# Access Compliance Report

## Public Rights-of-Way

### (Curb Ramps)

Intersection ID: 47572	Main Street: HERMSLEY_RD	Cross Street: BARRANDS_LN	Location: NW
ADA ID: 4C9E140753E7	Ramp Type: PerpDiag	Initial Pass/Fail: Fail	Overall Compliance: No
Severity Score: 8.75			
Codes/Mitigation Info/Possible Solution		Field Measurements/Component Compliance

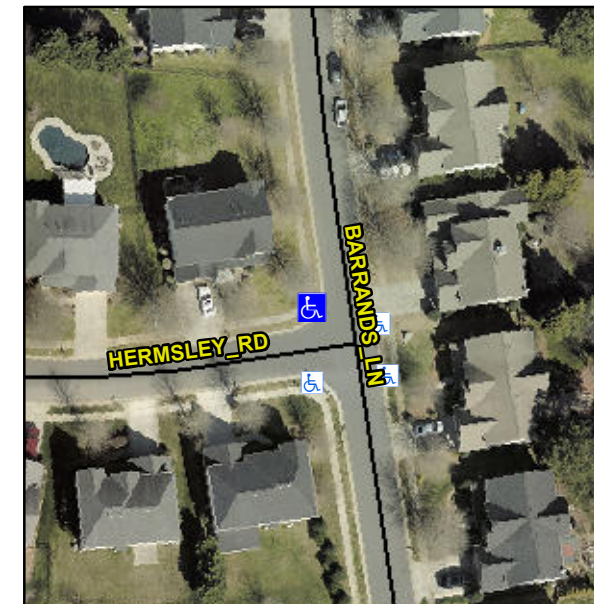
**Remove & Replace Curb Ramp With Two New Directional Ramps or Equivalent.**

**Not Found, R304.5.1**
